From: [Miller, Ed](#)
To: [Kuntz, Robert](#)
Subject: FW: NRC Staff Comments on Scenario Based IA Example Sections 1-6
Date: Wednesday, October 30, 2013 10:41:00 AM
Attachments: [Draft WORKING EXAMPLE 06-12-2013 staff feedback.pdf](#)

Rob,
The attached file contains the NRC staff comments on NEI's scenario-based integrated assessment example, Sections 1-6 from the October 24, 2013, public meeting.

Scenario Based Integrated Assessment Evaluation of a “Sunny Day” Dam Failure with Advance Warning of an External Flood and Severe Site Flooding

June 12, 2013

Figure 2-1: Scenario Site Flood Profile

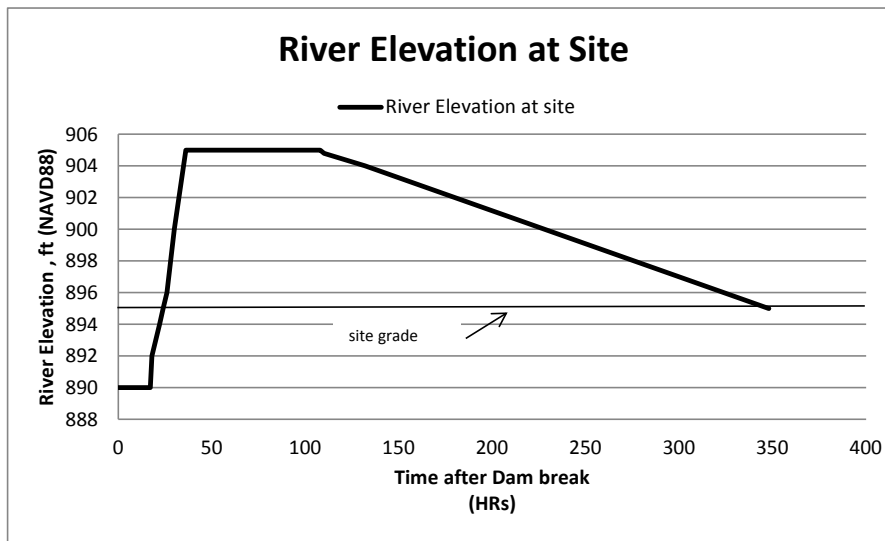
Comment [Suggest53]: Suggestion: Note earlier comment about consistency regarding the length of the "flood peak."

Comment [Suggest54]: Suggestion: Consider whether the following is an applicable consideration:

FIGURE 3-1 - PLANT LAYOUT
NOT TO SCALE

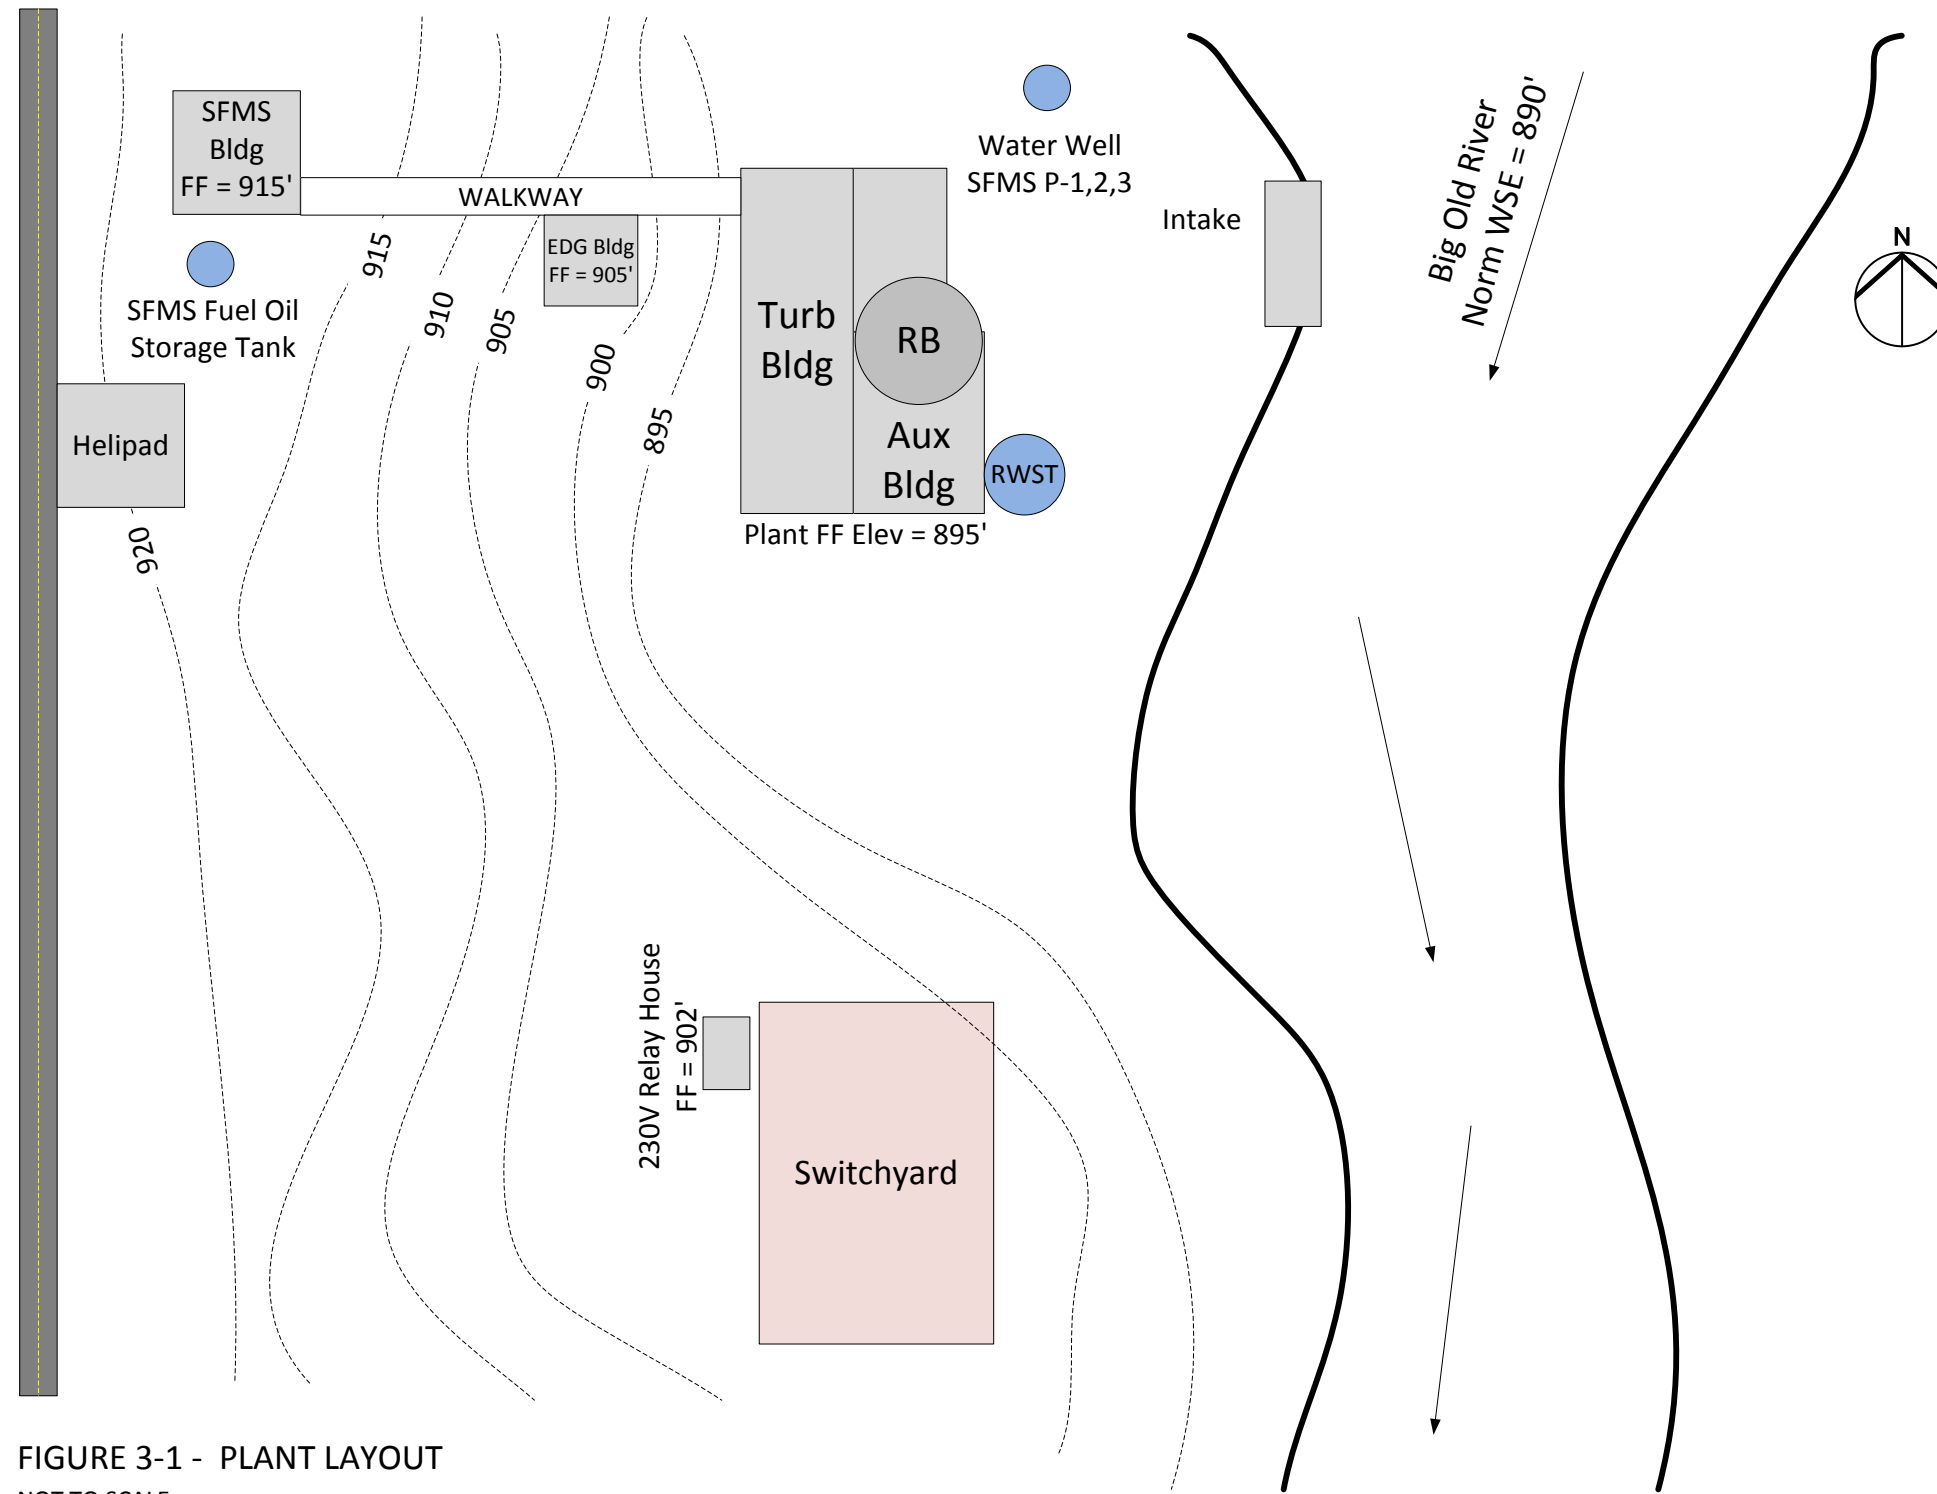
Comment [Edits63]: Editorial: To make this section easier to follow, consider introducing Fig. 3-1 as this point and including an overview of the site flood protection features/system.

FIGURE 3-2
SIMPLIFIED PLANT ELEVATION DRAWING
Not To Scale

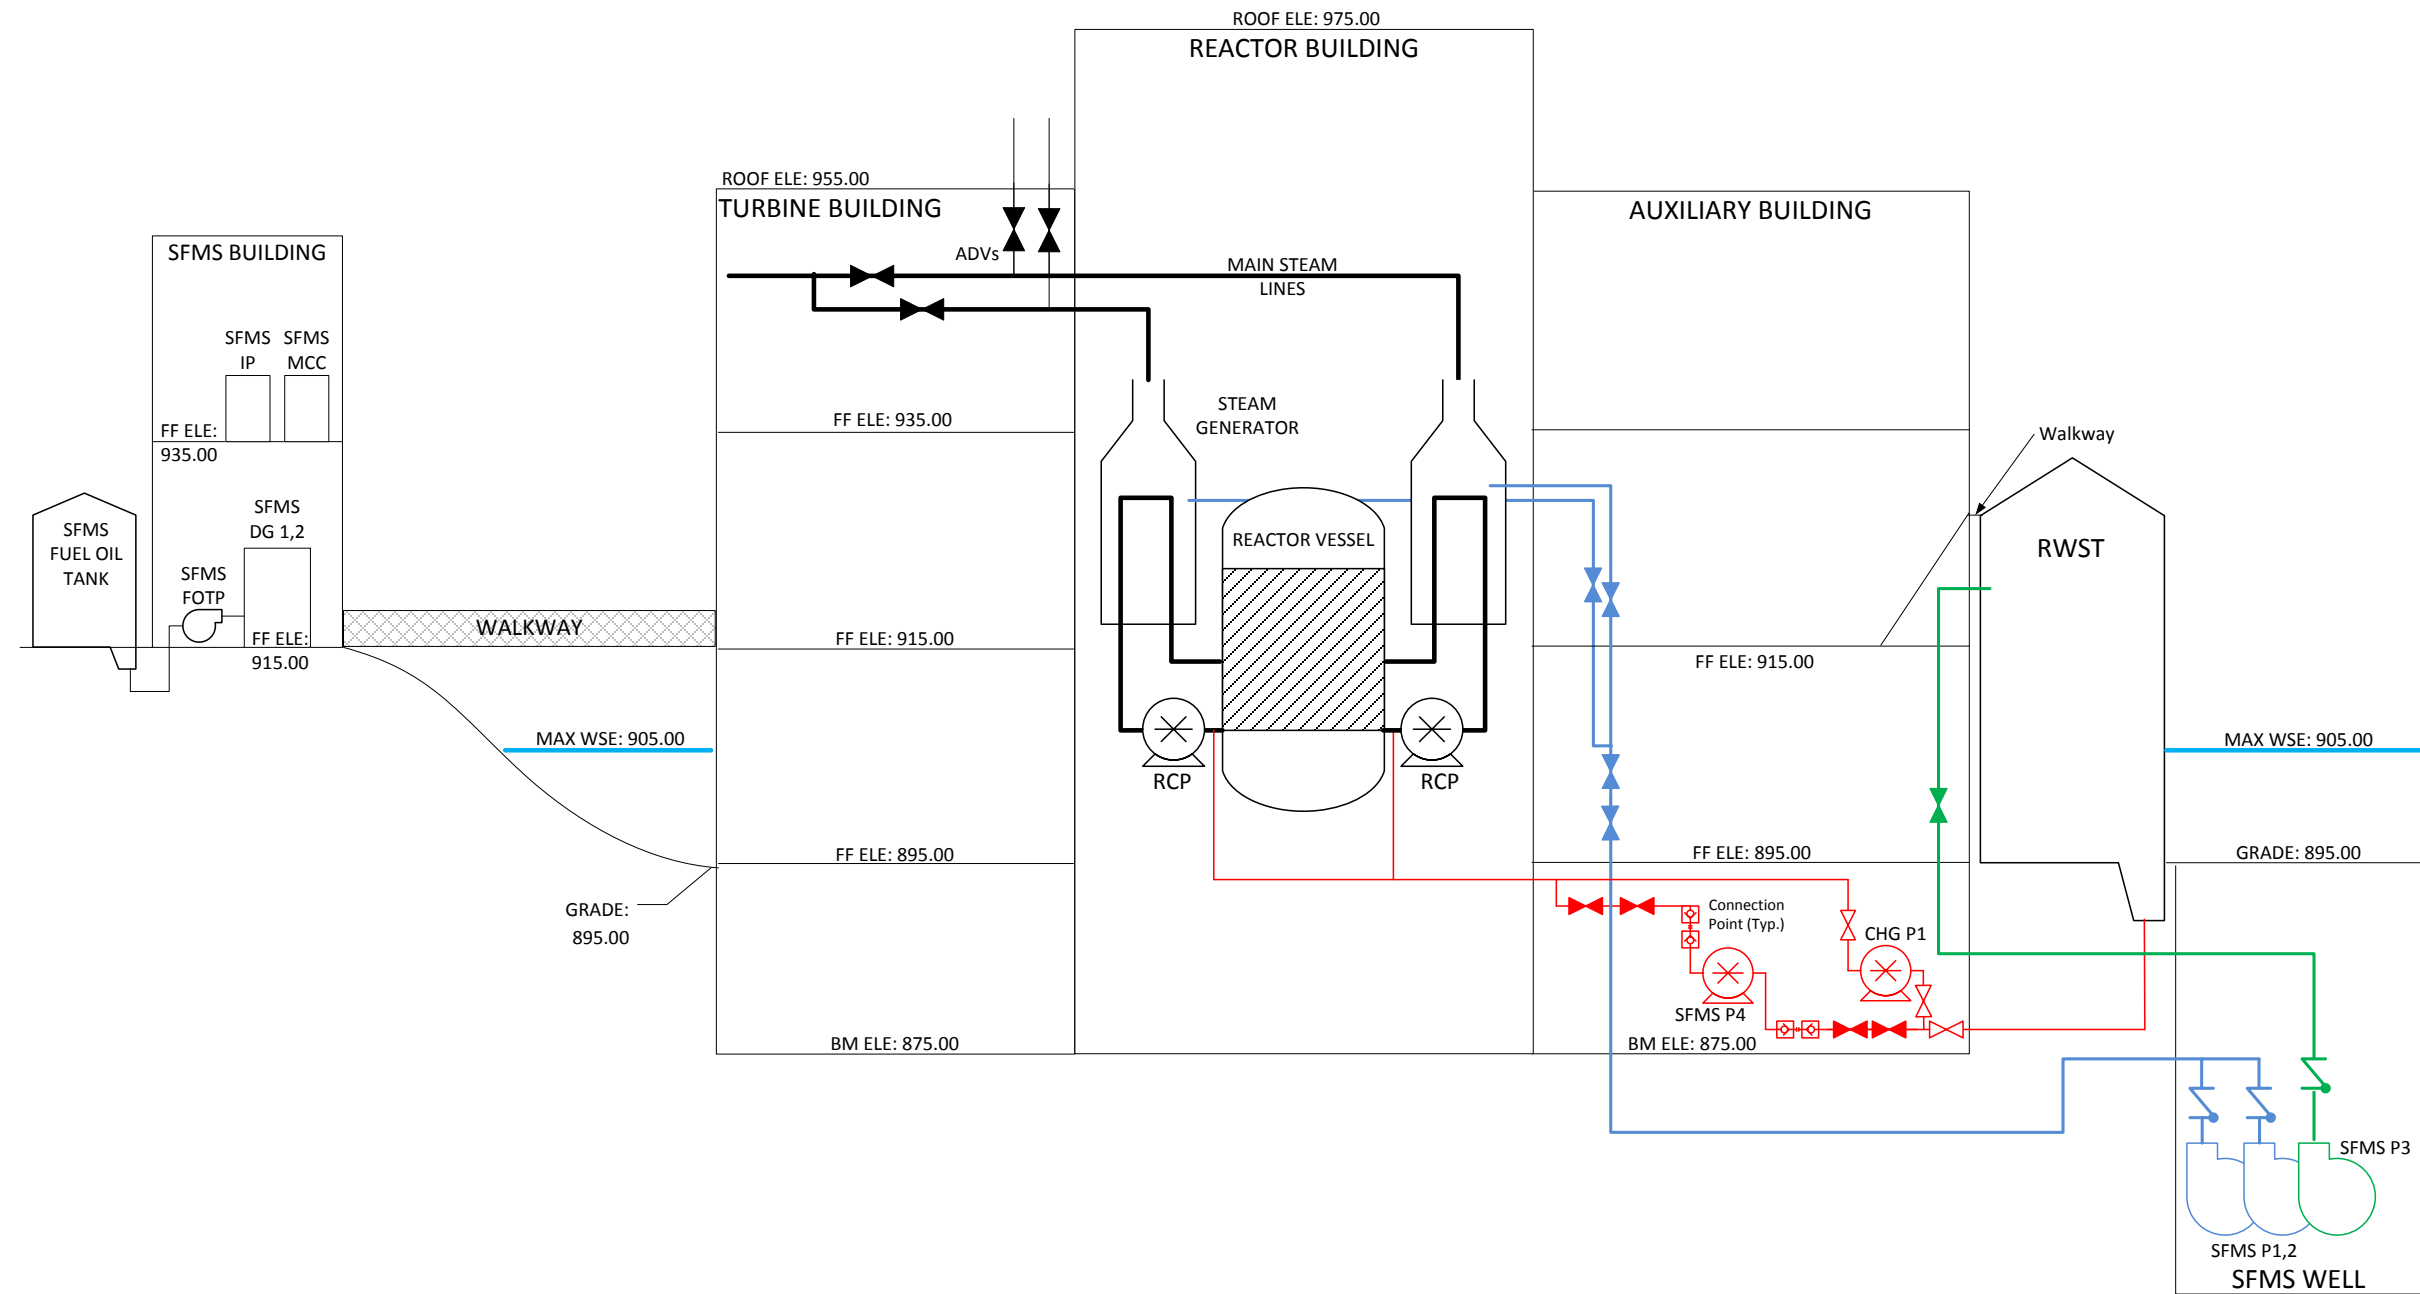
Comment [Edits109]: Editorial: Clarify which upper manway is being referred to (e.g., through reference to figure 3-2).

FIGURE 3-3 – Simplified Diagram of SFMS Electrical Distribution

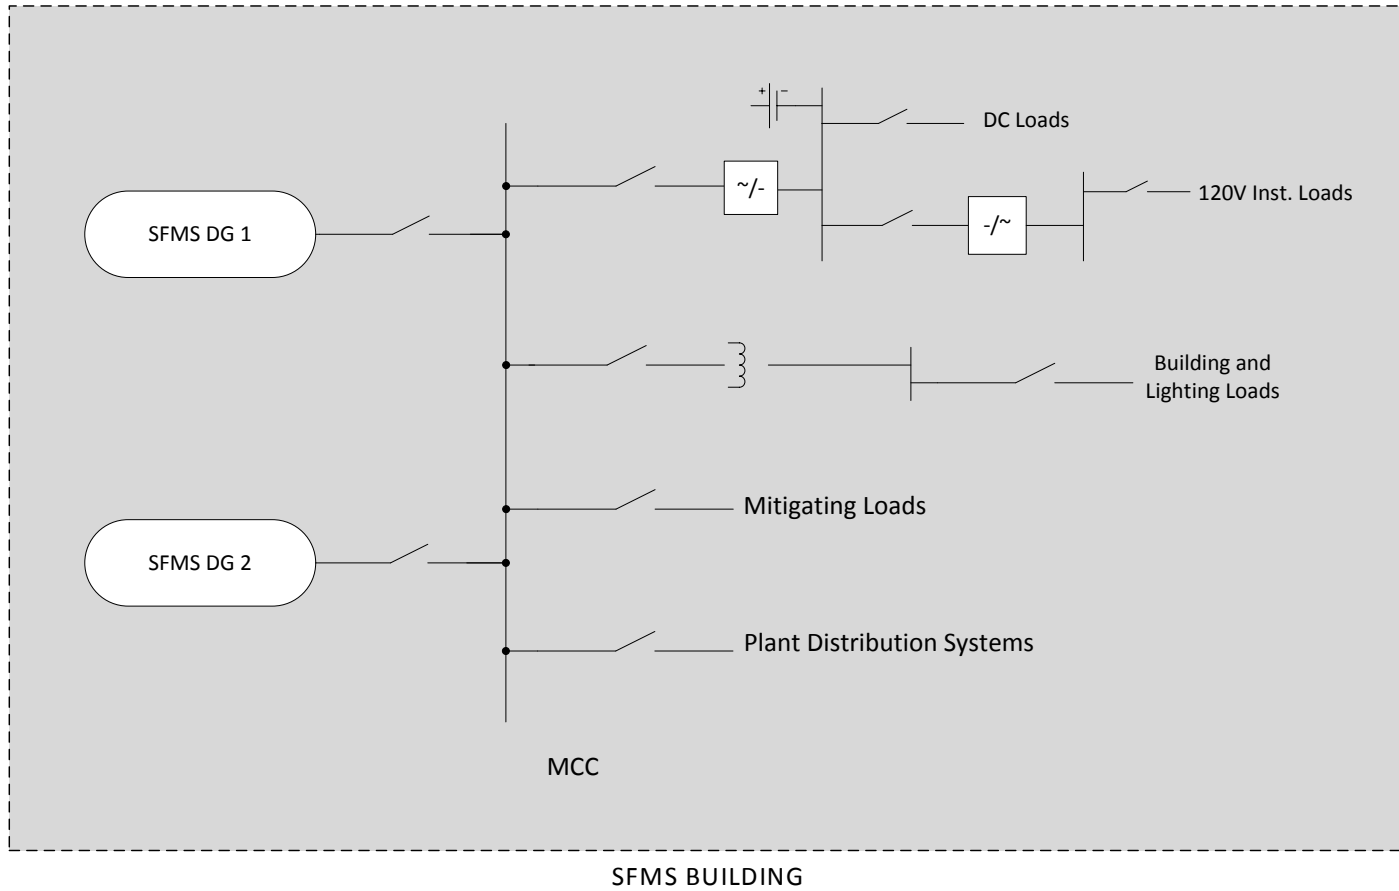
Comment [Clarify104]: Clarification needed: Is this step intended to be a deliberate disconnect during the startup sequencing for the flood event? Is it intended that the SFMS be available to provide power when there is no flooding? Figure 3-3 indicates the possibility of powering other load sets. 3-1

Figure 6-1 – Scenario Success Path

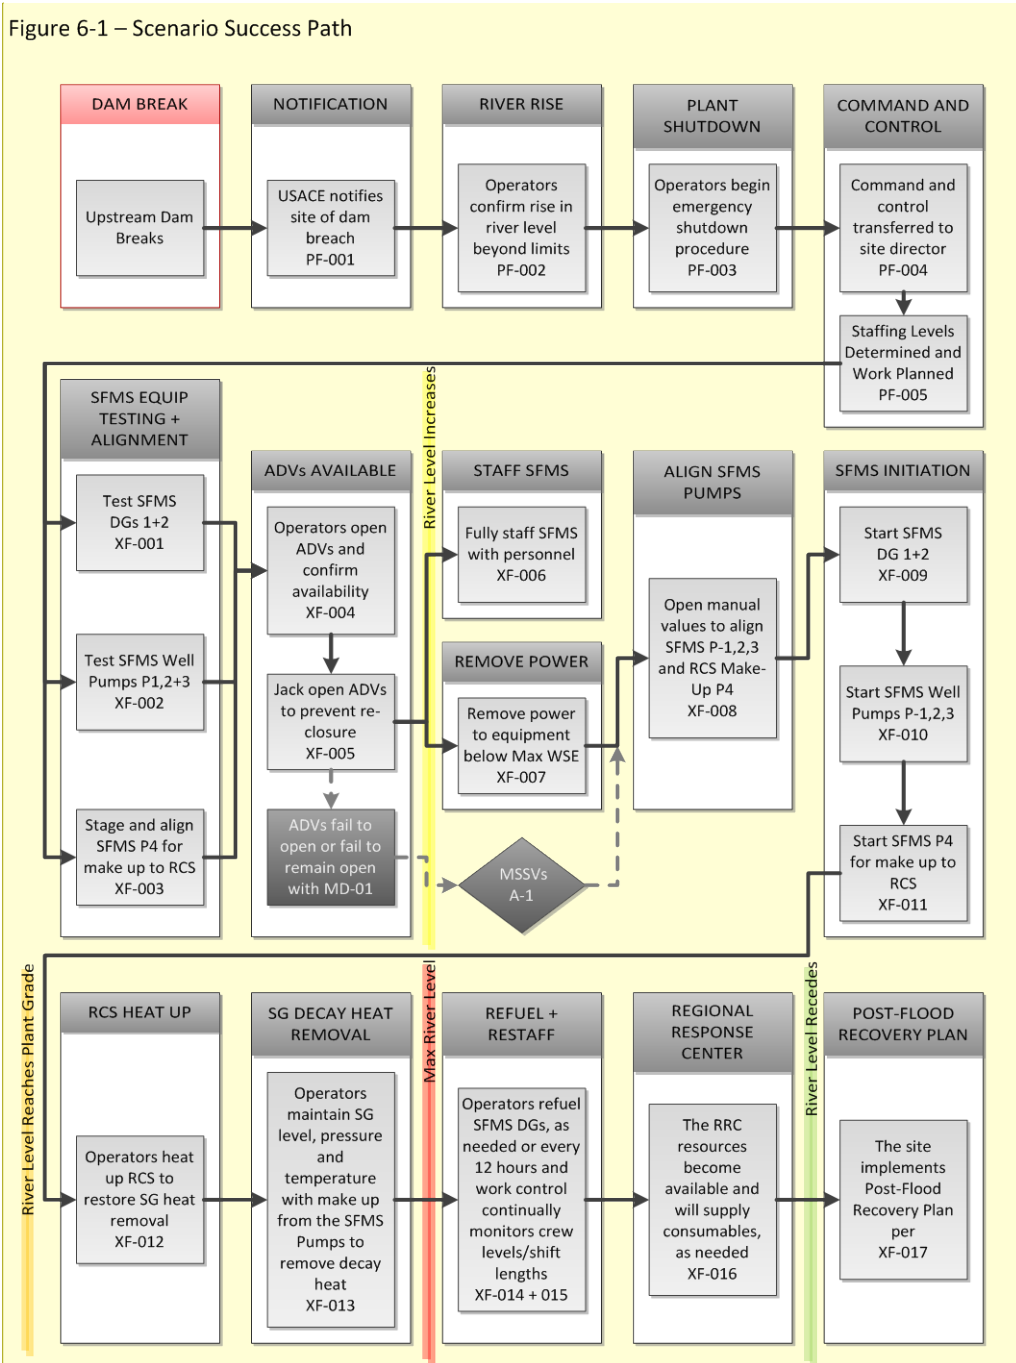
Comment [Suggest153]: Suggestion: Other places in the document references the state notifying the site whereas this figure USACE notifies the site. Consistency suggested.
